STAFF RECOMMENDATION

**101 Broadway
May 15, 2019**

Application: Signage

Description of Project: Application for wall paint and a painted sign, on the rear elevation of the building, fronting the alley, and visible from First Avenue South.

Figure 2: Rear and side elevations, looking north along First Avenue, South. Yellow box shows approximate proposed signage location.

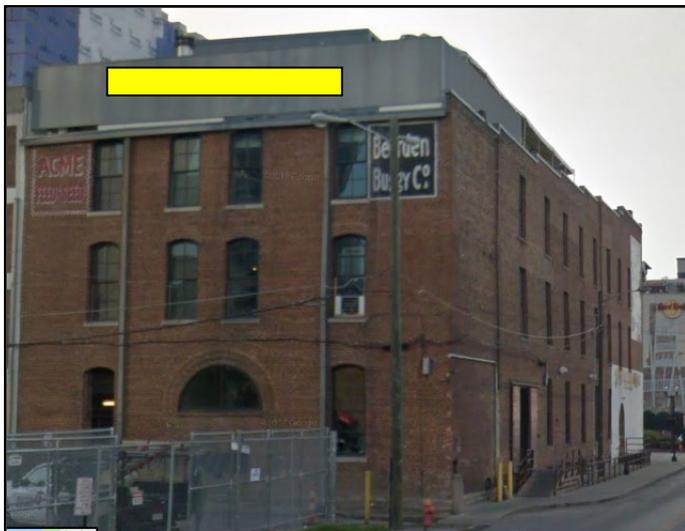
Analysis and Findings: The application is to paint a rear mechanical screen and to install a painted sign in the same area. The screen faces the alley and is visible from First Avenue South. Painted signage is a modification and must be reviewed by the Commission.

Materials: The proposed sign will be painted on an existing non-historic

corrugated metal rooftop mechanical screen on the rear of the historic building. Painted signage is only allowed by modification from the Commission.

The screen will be painted white with red checks. In general, the painting of historic buildings does not meet the design guidelines; however, this portion of the building is not historic and this building is noted in the design guidelines as an exception because of its historic white paint and red metal checks on the front and part of the sides of the building. The project meets

Location: The proposed location is on the rear elevation, and does not cover architectural features, which meets the guidelines.

Allotment & Design Standards: The painted signage allotment is one-hundred-twenty-five (125) square feet. The proposed sign will be one-hundred-twenty (120) square feet, which will meet this requirement. The white background and red checks were not counted as part of the signage, but rather as wall paint, since both are considered a historic architectural feature of the historic building. The design guidelines specifically call out Tootsies and Acme Fee as examples of historic painted buildings.

Staff recommends approval of the proposed painted screen wall and painted sign, finding that it meets the design guidelines II.M for paint and IV for Signage.
